Transbay Transit Center
San Francisco, CA
CM/GC Contract No. 08-04-CMGC-000
Project No. 30100

**BID PACKAGE TG07.9
ADDENDUM # 6**

TG07.9 – Bollards and Barriers

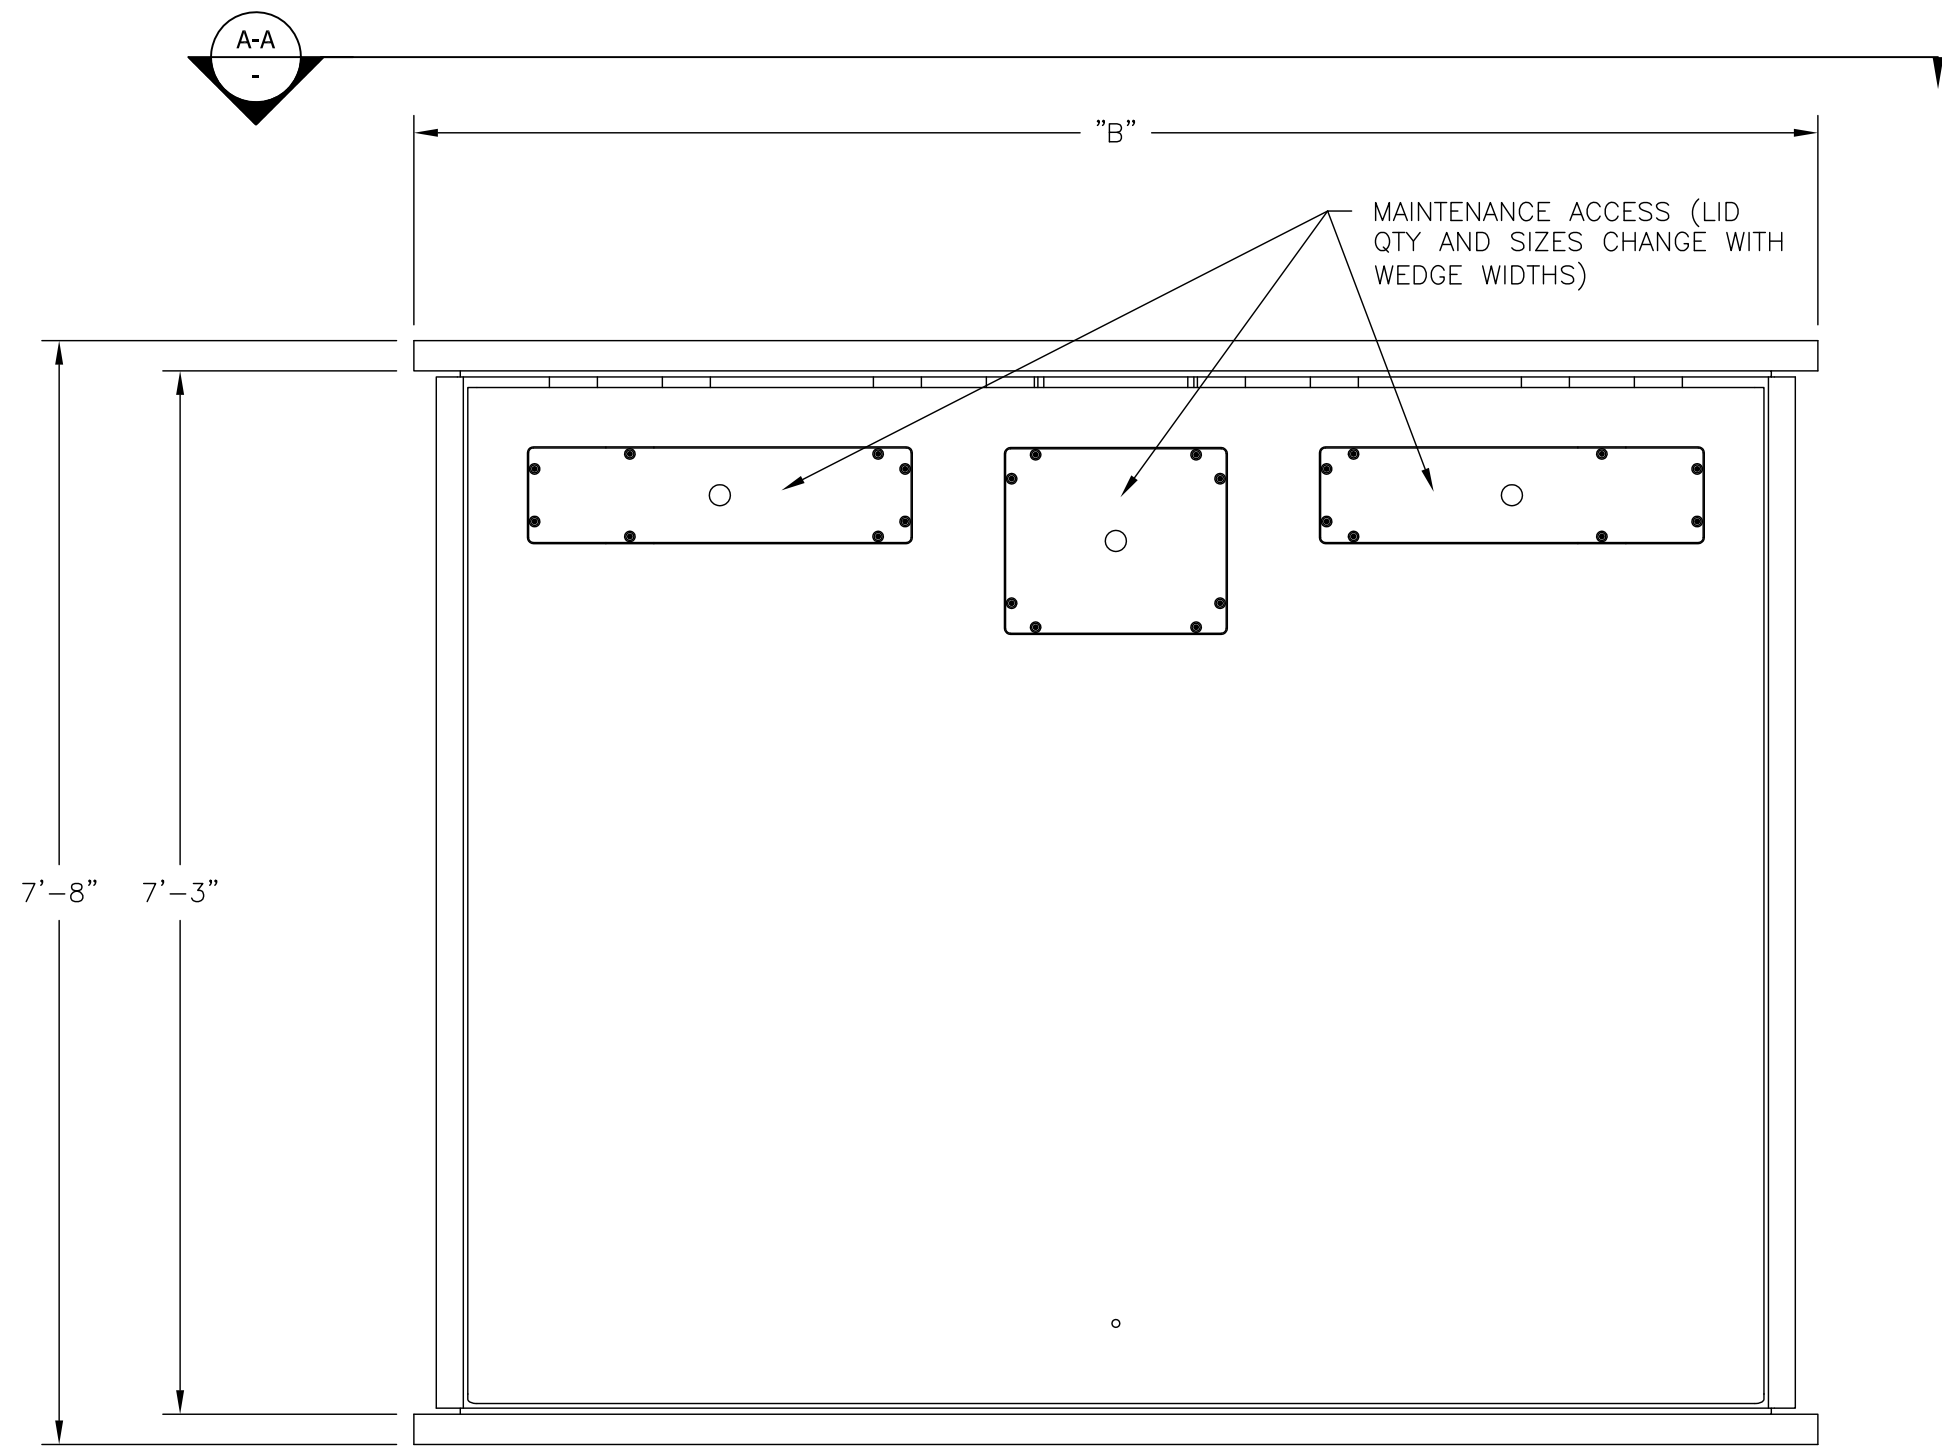
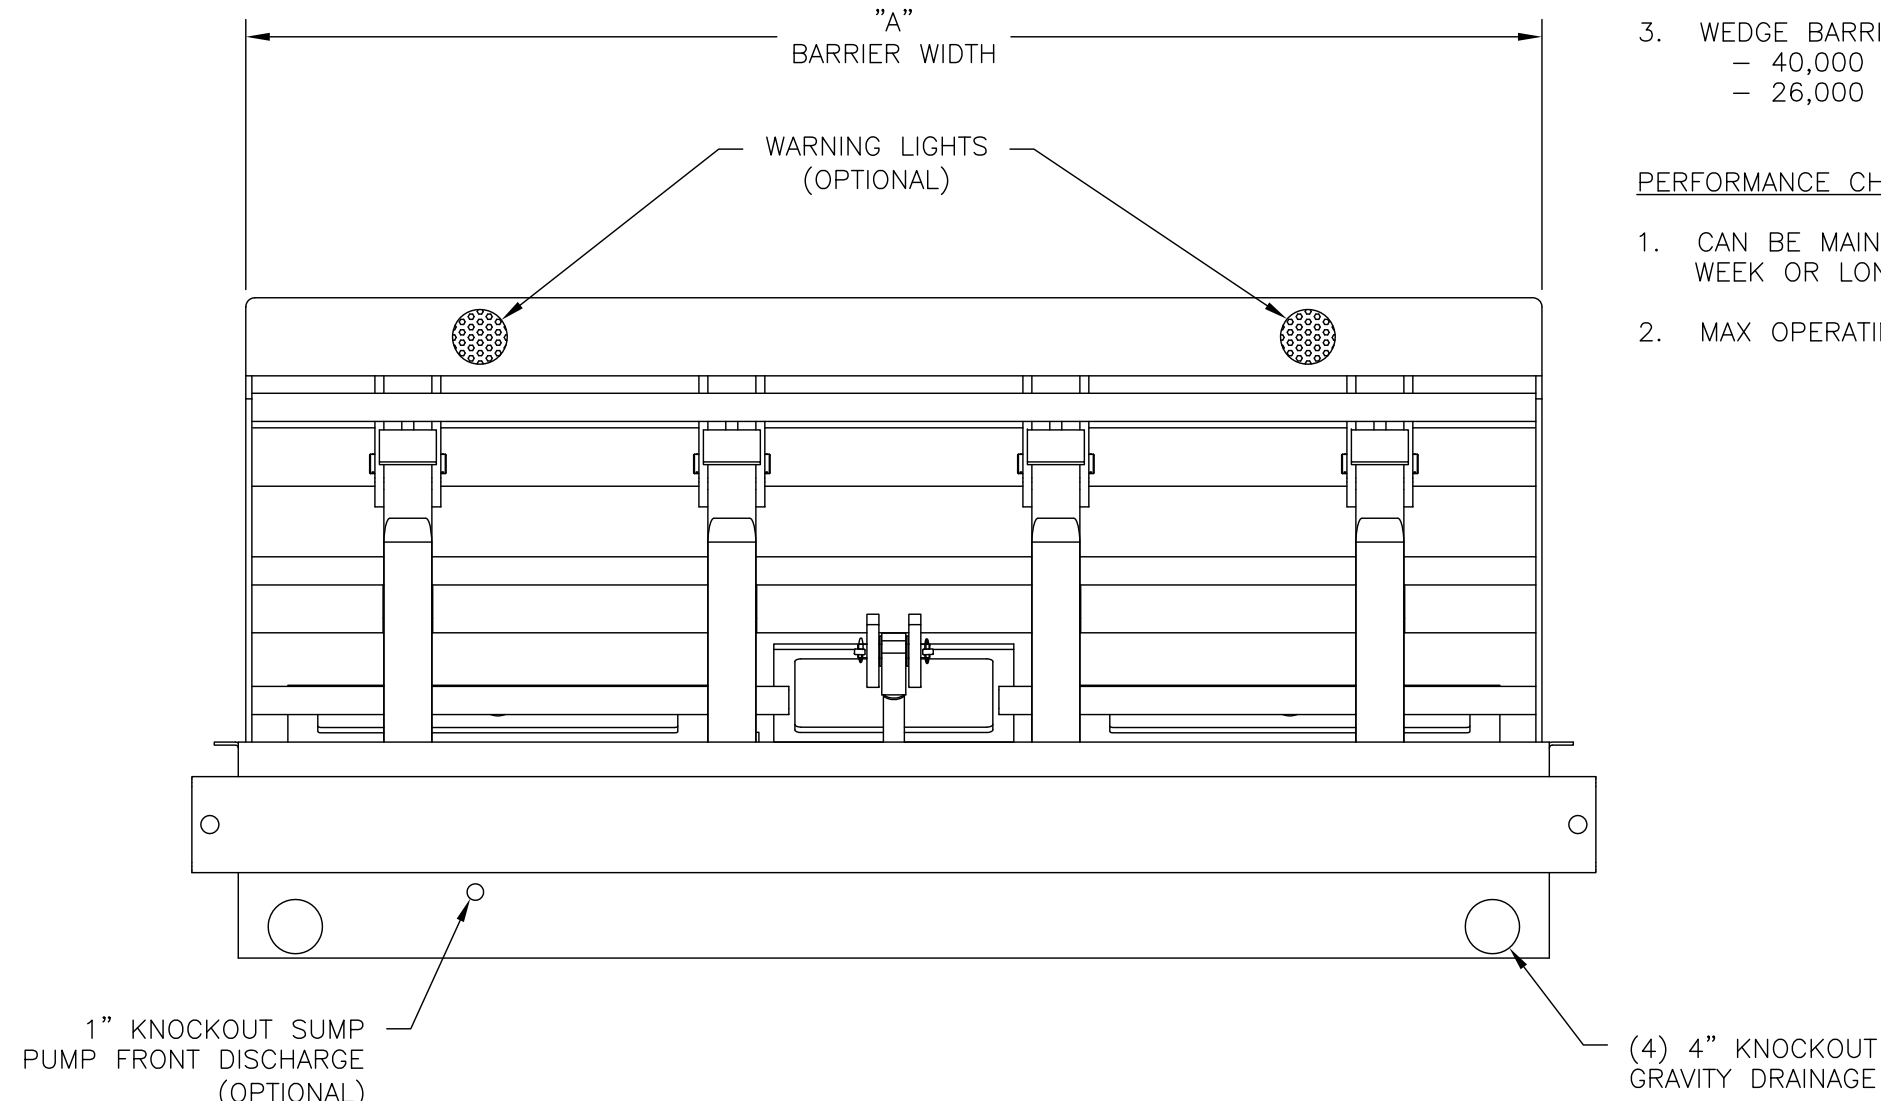
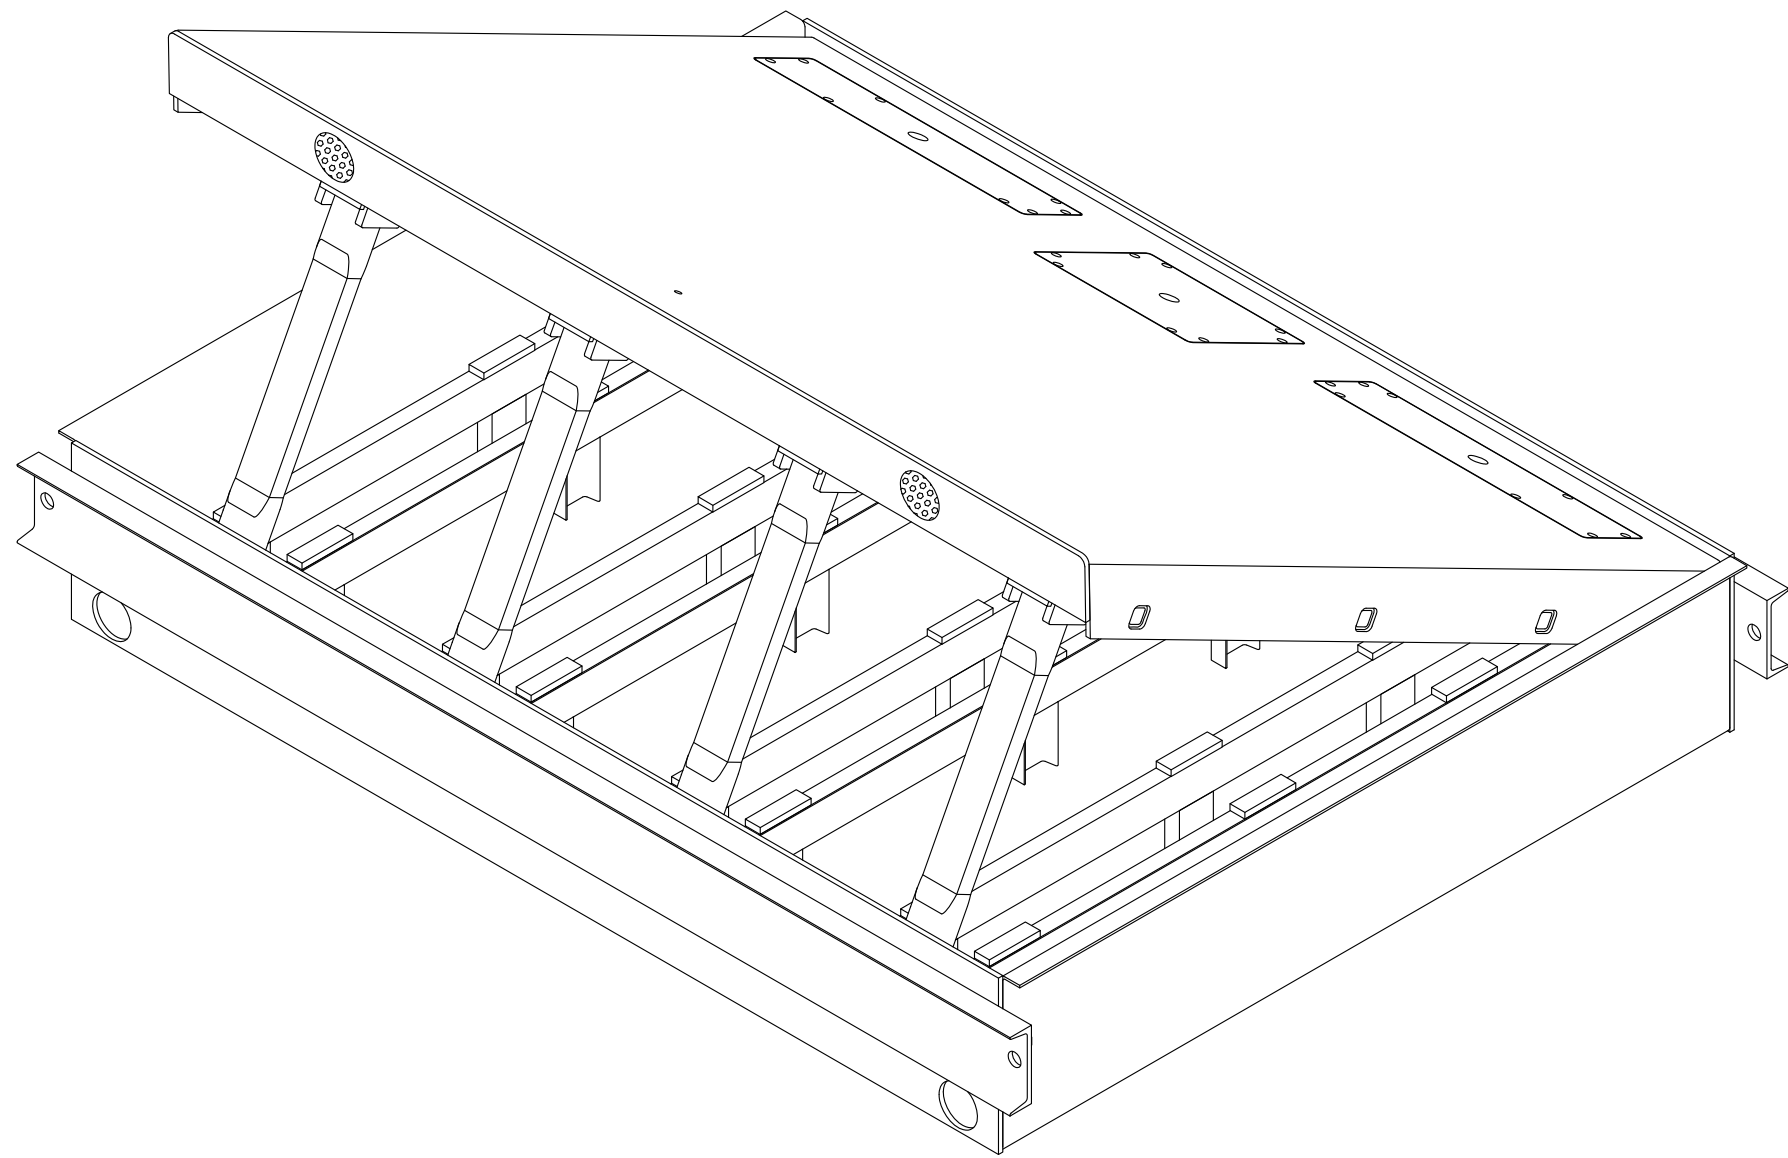
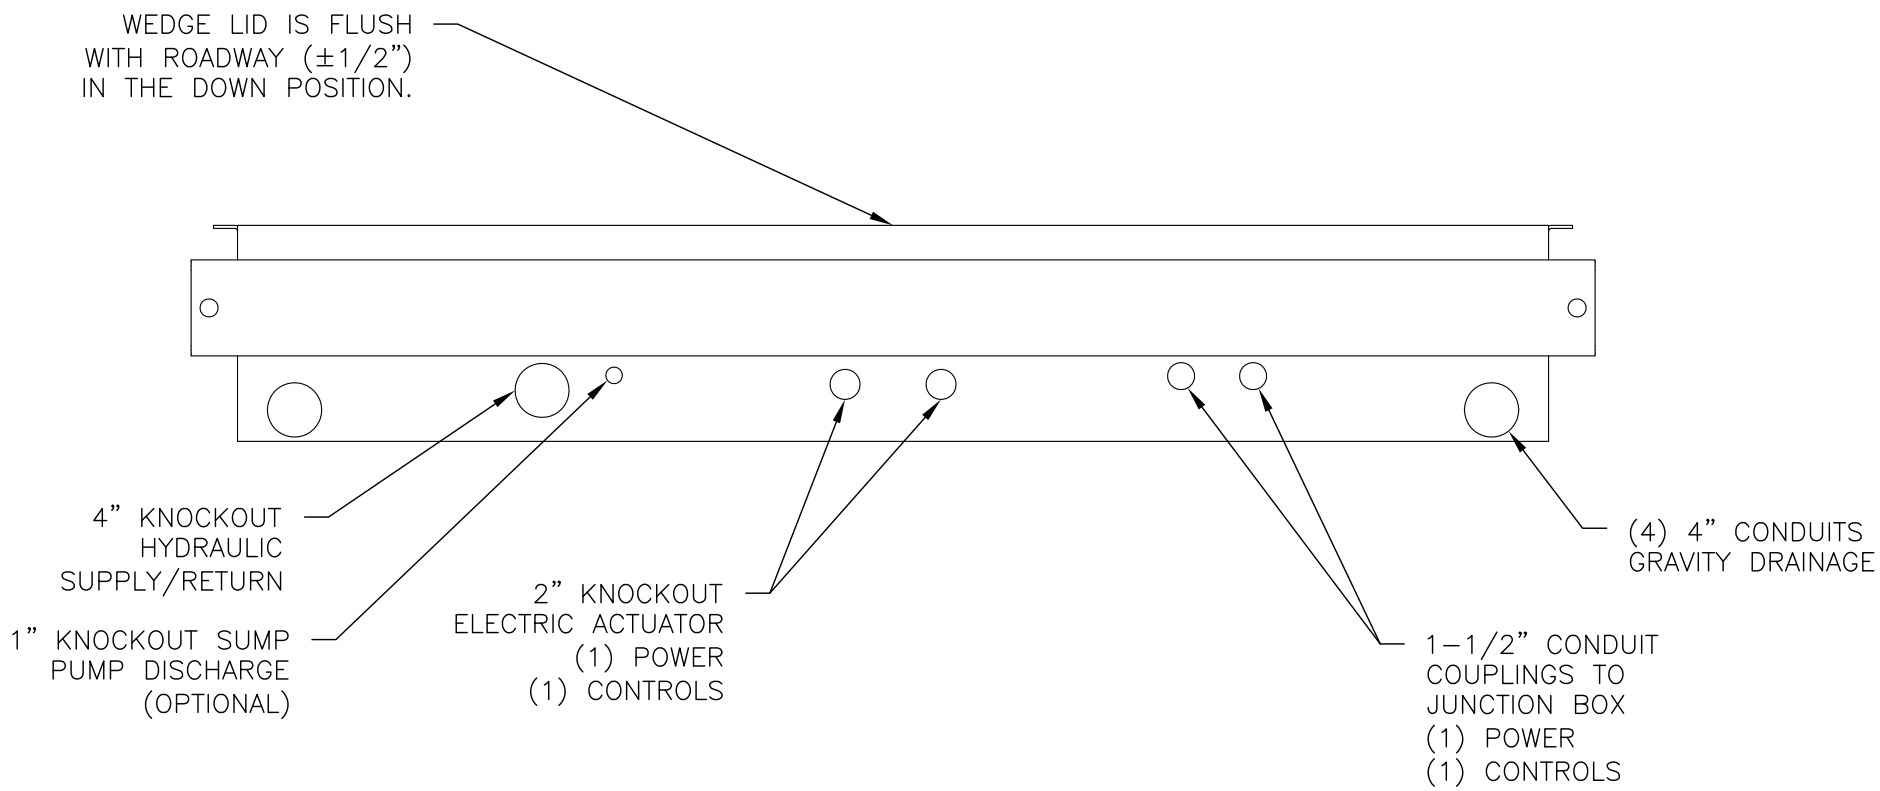
Question No.	Submission Date	Drawing No.	Document/ Spec. No.	Question	Response
TG07.9-001	8/20/2014		ASI 121 28 16 44	We respectfully request that proprietary M50 rated active vehicle wedge barrier (SW 1900) be added to the approved manufactured list. Please see attached documentation.	FutureNet is an acceptable manufacturer of phalanx barriers and operable bollards. The Trade Subcontractor will be required to submit specific product data for the FutureNet barriers they intend to provide that meets the criteria identified within Specification Sections 28 16 44 and 28 16 44/APA.
